Online submission

Submitter No.	S311
Submitter Name	Grant Marshall
Submitter first name	Grant
Submitter middle name	Allan
Submitter surname	Marshall
Submitter is contact	Yes
Email	info@nzfernz.co.nz
Wish to be heard	Yes
Joint presentation	Yes
Trade competition	I could not gain an advantage in trade competition through this submission.
Directly affected	N/A
Withhold contact details?	No

Subject: GNS Client Report 2008/11 review of Lake Poerua subdivision

Updated Review of Proposed Lake Poerua Subdivision, Grey District

Figure A. Map showing suggested Fault Rupture and Deformation Avoidance Zones in the NE part of the Lake Poerua subdivision. The green line shows the expected seiche inundation level (from the lake) across this area. The blue line demarks the area covered by schistose fan debris.

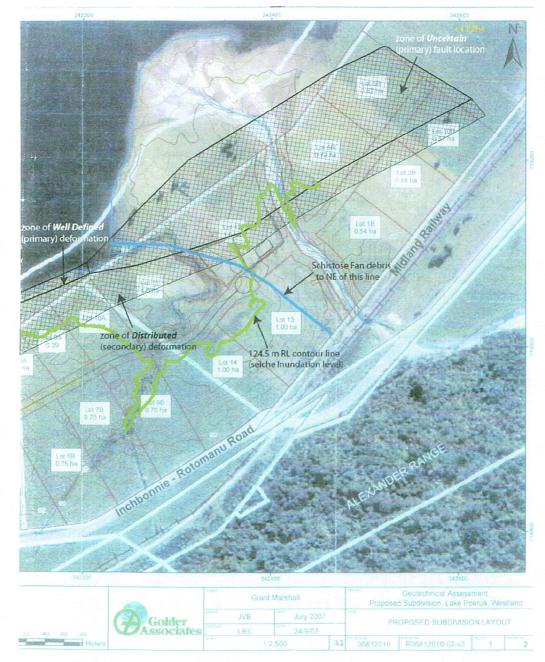
When the fault is so poorly located it is very difficult to quantify a zone of associated distributed deformation. In this instance, a zone of 20 m has been added to the upthrown (SE) side of the hachured "Uncertain" zone on Figure A. Again, for those areas shown inside this hachured area the MfE Guidelines suggest a *Discretionary* and *Non-Complying* resource consent activity status for BIC 2a and 2b structures, respectively.

Seiche inundation has been described in Golder Associates (2007) report. Their analysis talks about a minimum building platform elevation of 124.5 m RL, i.e. relative to their survey map. I concur with this finding. This contour is shown by the green line on Figure A. The area of inundation covers part of Lot 9, most of Lots 10 & 12, all of Lot 11, and the low frontal edge of Lots 13 & 14.

Inundation and/or *falling debris* hazards are a threat to the area of Mine Creek. Based on the current distribution of fan materials, i.e. where schist-derived fan debris has been mapped by Golder Associates (2007), Lots 12 and 13 would be affected by future re-activation of the fan. Lot 12 is entirely encompassed by the fan and schistderived deposits. The northern half of Lot 13 is sited across schistose fan material. As a mitigating measure, Golders Associates (2006; 2007) have proposed to construct a 2 m high bund along the edge of the channel of Mine Creek. This may prove effective at diverting material from Lots 12 and 13. However, the bund would need to extend to the SE of the property limits to prevent any debris flow material 'jumping out' of the channel and across those lots.

d – building platform must be placed above green seiche inundation line (see Figure A)

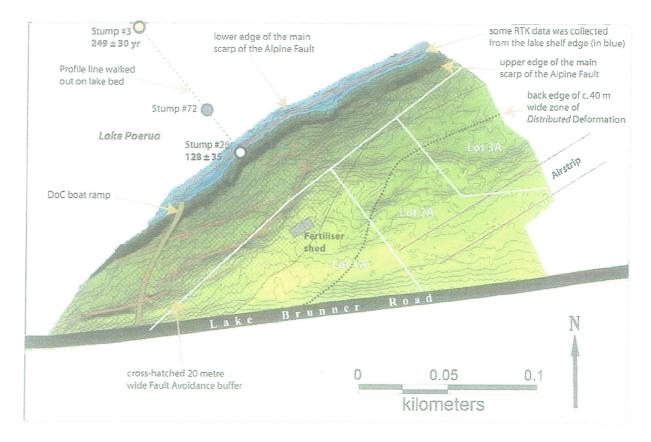
- the amendment of the boundary between Lots 1A and 2A is reasonable to avoid possible fault traces at the SW corner of the subdivision and to allow more flexibility for siting house lots outside of designated hazard zones (see Figure 1 of this letter).

Approximate Lot boundaries have been placed on here (I understand these are going to change). My concerns about Lot 1A are reflected in the potential fault traces shown near Lot 1A. An arcuate scallop-shaped feature exits across Lots 2A and 3A. It is not mapped and its origin is unknown (slump scar?).

The bathymetric profile was useful in pinning down where the gradient of the lake bottom changed – it steepened up dramatically within the last 7-10 m of the lake shore at this spot. The uncalibrated radiocarbon dates on tree stumps shown, helped indicate that there has been significant lake level changes in the past. Stump #3 was found under c. 1.5 metres of water.

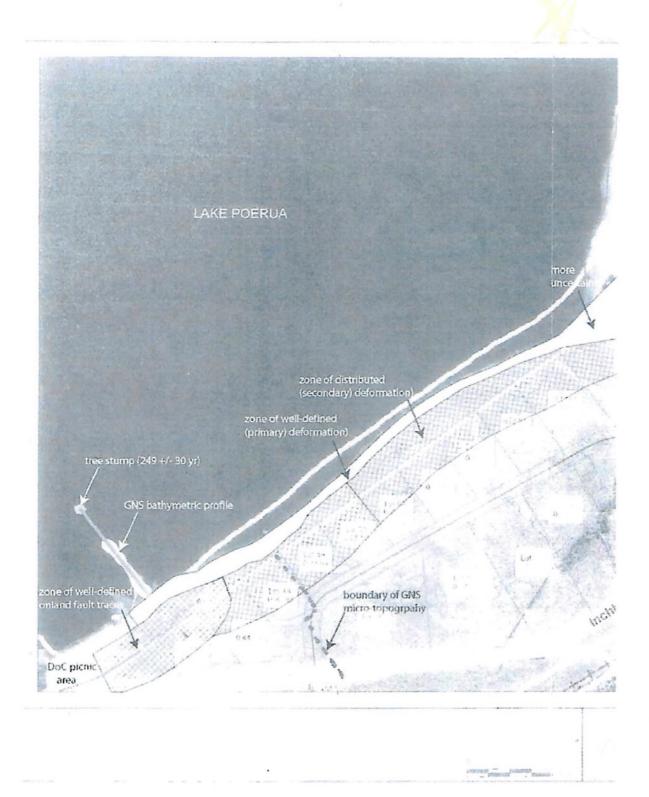
The scan presented as Figure 3 in Langridge & McSaveney (2007) did not extend to the NE end of the proposed site as I was unaware that the area of Mine Creek was still being considered for subdivision in the current scheme. A number of hazards have already been identified in relation to these lots: fault rupture; fault deformation; inundation from seiche wave; and inundation/debris flow from Mine Creek. These will be discussed further below.

- Can you also clarify the situation in respect of Lots 11 (the extent of the secondary formation is not fully shown on your Figure 3) 12, 13 and 14-all are proposed to be built upon. In the Conclusions and Recommendations 5. and 6. doubt is cast on the suitability of lots 11 and 12 at least.
